GE Monogram

Service Bulletin

GE MONOGRAM REFRIGERATORS REF 13-00
BOTTOM-MOUNT ZIC36 - RH & LH MODELS
PRODUCED DECEMBER 1999 TO CURRENT

Auxiliary Evaporation Fan

Figure 1

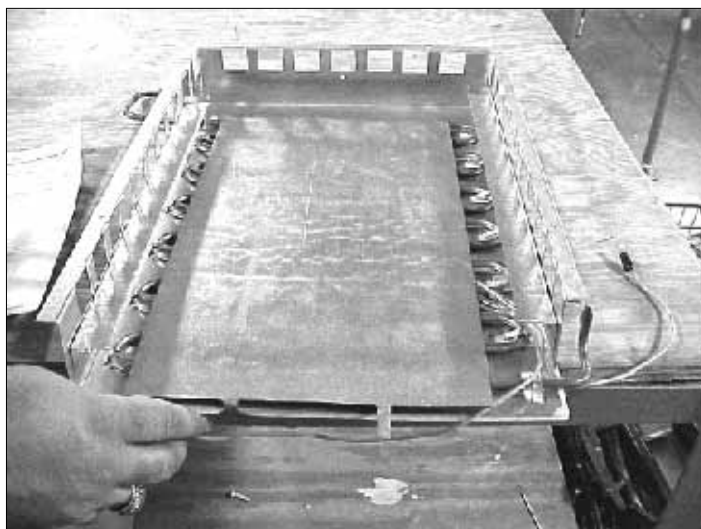
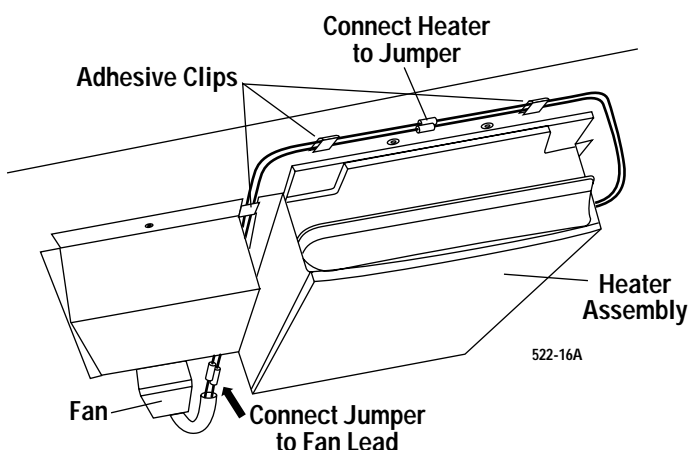
Should the fan fail or the customer complain of excessive fan noise follow the instructions below for Heater Kit WR49X10016.

4. Heater Installation:

- Remove drain pan - be careful not to spill water from the pan.
- Install heater assembly over auxiliary condenser (See Figure 1).
- Connect the heater leads to jumper harness lead.
- Re-install the drain pan and toekick.
- Make sure directional arrow on drain pan is pointed to rear of refrigerator.

Heater assembly is laid into place and attached by folding the front tabs down. The **rear flange** of the heater assembly is **over** the **next-to-last** tube of the auxiliary condenser. **Note: Edge trim is used wherever a wire is laying over a sharp edge and wires must be routed so as to prevent contact with the drain pan.**
